<b>Subject:</b> HESITATION / IDLE VIBRATION DUE TO CRACKED ENGINE MOUNT	<b>Bulletin No:</b> 01-016/10
	<b>Last Issued:</b> 06/16/2010

- This bulletin supersedes the previous bulletin 01-021/06 issued 6/13/06, 01-001/09 issued 01/20/09, and 01-016/10 issued 02/17/10. The APPLICABLE MODEL(S)/VINS, PART(S) INFORMATION, and WARRANTY INFORMATION have been revised.
- Changes are noted below beside the change bar in Red.

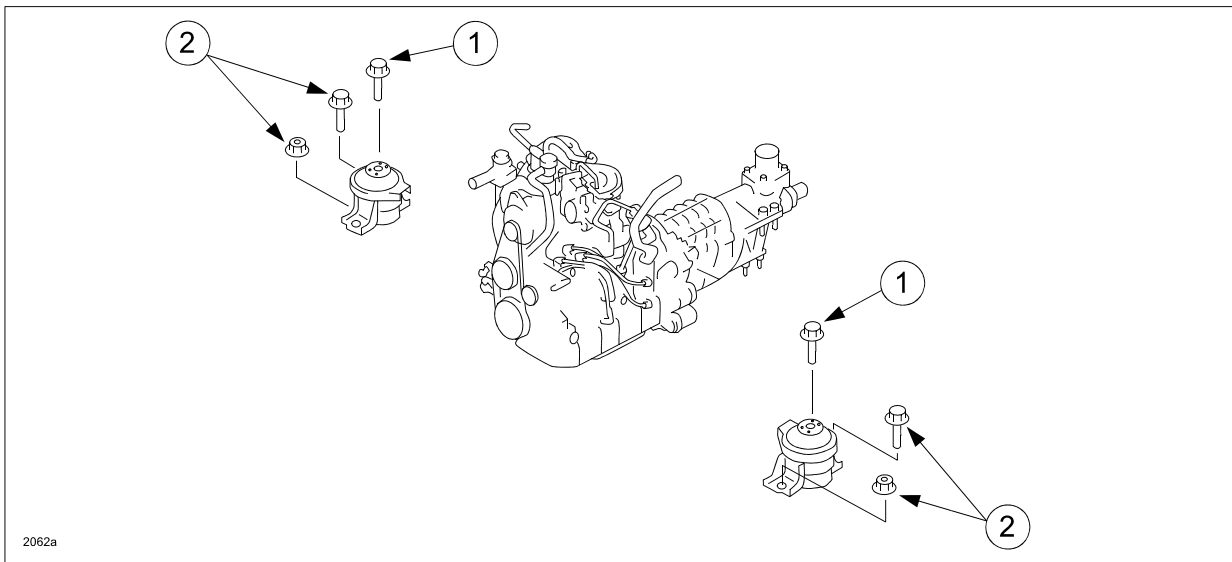
Depending on the driving condition or engine condition, the RH side engine mount rubber may deform. As a result, the RH side engine mount can crack. As a mass production change, the material of the engine mount rubber has been changed.
